**2015 Audit of**  
***LOS ESTEROS CRITICAL***  
***ENERGY FACILITY***  
**DECEMBER 2015**

**STAFF REPORT**

**PREPARED BY THE ELECTRIC SAFETY  
AND RELIABILITY BRANCH OF THE SAFETY AND  
ENFORCEMENT DIVISION**

# AUDIT REPORT OF LOS ESTEROS CRITICAL ENERGY FACILITY

Figure 1: Schematic of the plant’s entry road and main gates (not-to-scale).

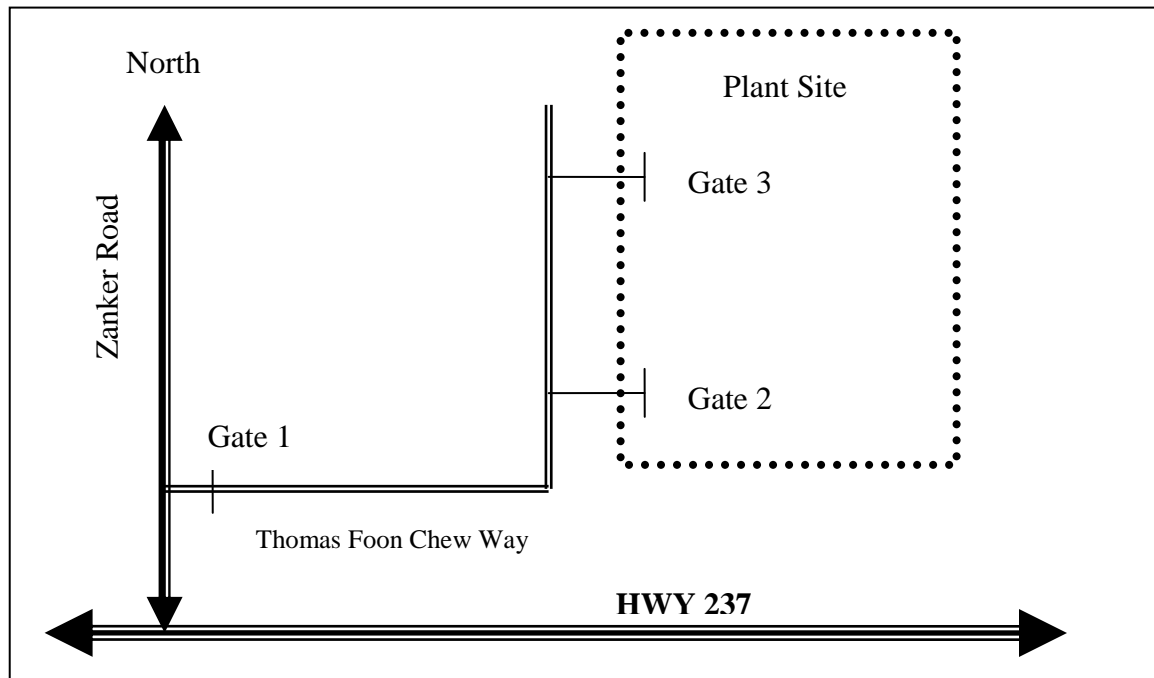
A street sign and a sign identifying the plant were missing on the road leading to the plant. This can delay the arrival of emergency personnel responding to fires or accidents at the plant, a violation of Operation Standard<sup>2</sup>.

The street sign “**Thomas Foon Chew Way**” was missing at the intersection of Zanker Road, where the plant shares its entrance with PG&E and Silicon Valley Power. This entrance has a security gate controlled by the plant’s operator. Vehicles must travel approximately half a mile past this security gate to arrive at the plant’s two entries. One entry has a remote controlled security gate and the other has a manually locked security gate (See Figure 1). It was not apparent to visitors which gate is the correct entryway.

In response, the plant posted a street sign and a company sign at Gate 1. The plant also posted a directional sign at Gate 2 to direct visitors to Gate 3, which is the plant’s main entrance. No further corrective action is required at this time.

Photo 5: Operating procedure and warning signs posted on an air switch.

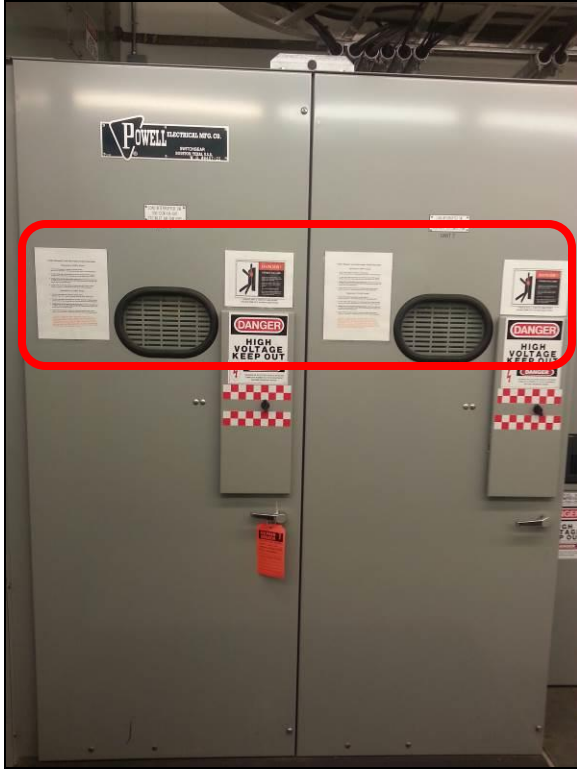
The plant lacked proper operating procedure for an air switch, which resulted in a worker’s injury in April 2009, a violation of Operation Standard<sup>15</sup>.

- Developed a detailed operating procedure
- Posted the procedure and added warning signs on the switch
- Briefed workers on the switch’s hazard
- Informed Calpine’s fleets of this hazard

Auditor reviewed the procedure and inspected the switch to verify postings of the procedure and warning signs. The switch is a 4 kV vertically racked air switch. It shuts power to the plant’s two chillers, which the plant uses to chill inlet air for the gas turbines. The plant has four of these switches, all located inside the 4 kV load center. Since the 2009 injury, the plant has not had any incident involving these switches. No further corrective action is required at this time.

Figure 2: Thermal image of a gas turbine exhaust cylinder.

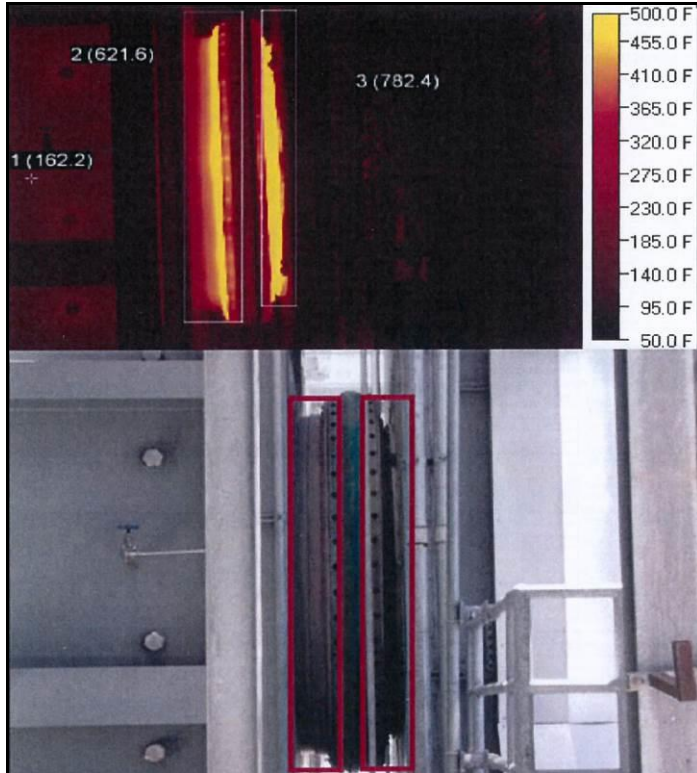
The plant fails to repair hotspots, a violation of Operation Standards<sup>33</sup>. Auditor reviewed a thermography inspection report<sup>34</sup> and noted hotspots at the gas turbines’ exhaust cylinders<sup>35</sup>. Thermal images showed the cylinder registered a temperature well above 500°F.

Photo 7: Unit 2's cylinder split opened at flange. *Source: Calpine*

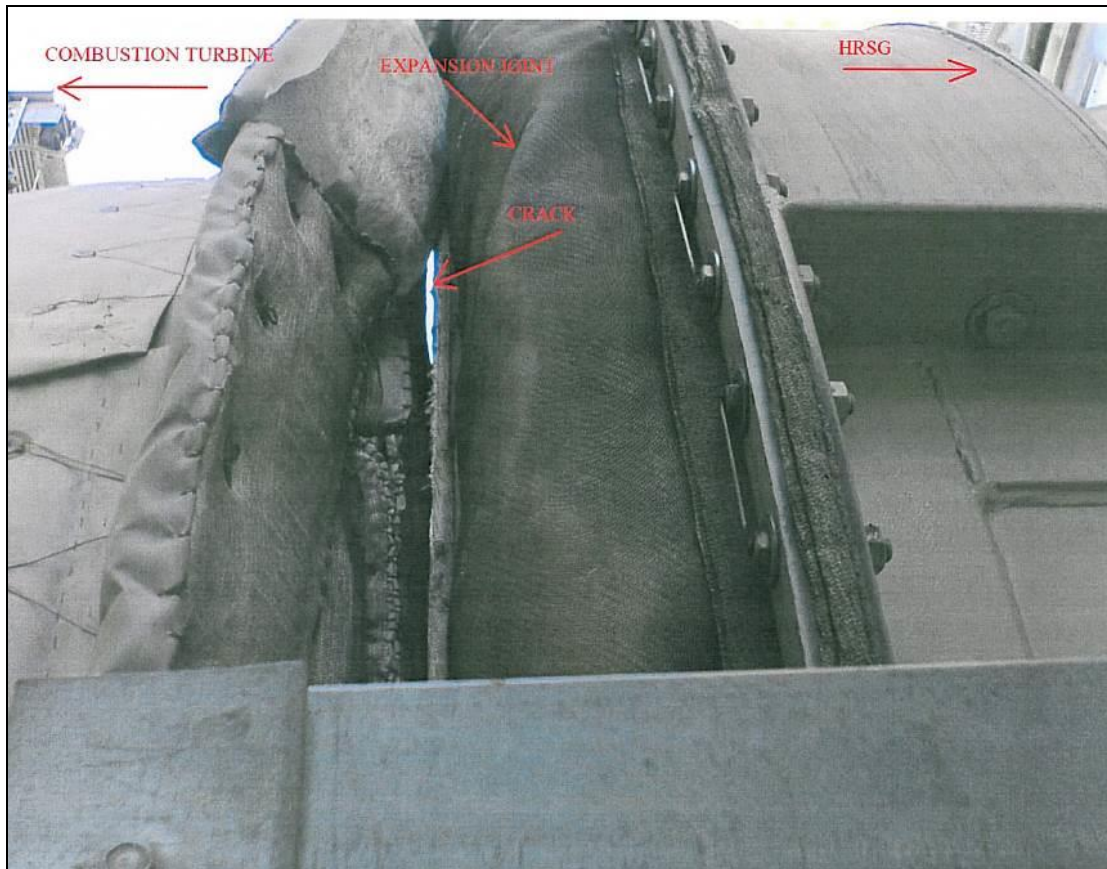
Three months later in June 2007, Unit 2's cylinder also failed. This resulted in a forced outage that lasted more than a week.

Aside from affecting reliability, hotspots also present a burn risk hazard for workers.<sup>36</sup> The plant must take corrective action to repair hotspots.
